# Office Action Summary

10/042,177

## **DETAILED ACTION**

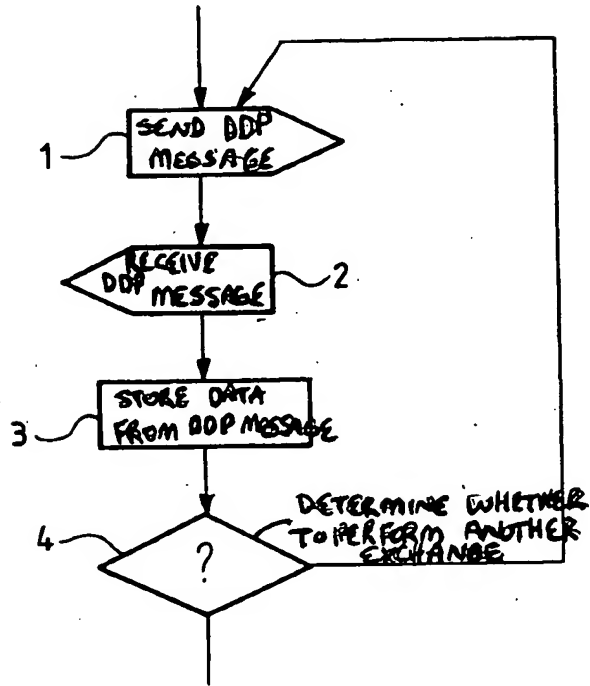
1. The drawings are objected to because the circle below "Hello Received" should have a descriptive label. Corrected drawing sheets in compliance with 37 CFR 1.121(d) are required in reply to the Office action to avoid abandonment of the application. Any amended replacement drawing sheet should include all of the figures appearing on the immediate prior version of the sheet, even if only one figure is being amended. The figure or figure number of an amended drawing should not be labeled as "amended." If a drawing figure is to be canceled, the appropriate figure must be removed from the replacement sheet, and where necessary, the remaining figures must be renumbered and appropriate changes made to the brief description of the several views of the drawings for consistency. Additional replacement sheets may be necessary to show the renumbering of the remaining figures. Each drawing sheet submitted after the filing date of an application must be labeled in the top margin as either "Replacement Sheet" or "New Sheet" pursuant to 37 CFR 1.121(d). If the changes are not accepted by the examiner, the applicant will be notified and informed of any required corrective action in the next Office action. The objection to the drawings will not be held in abeyance.
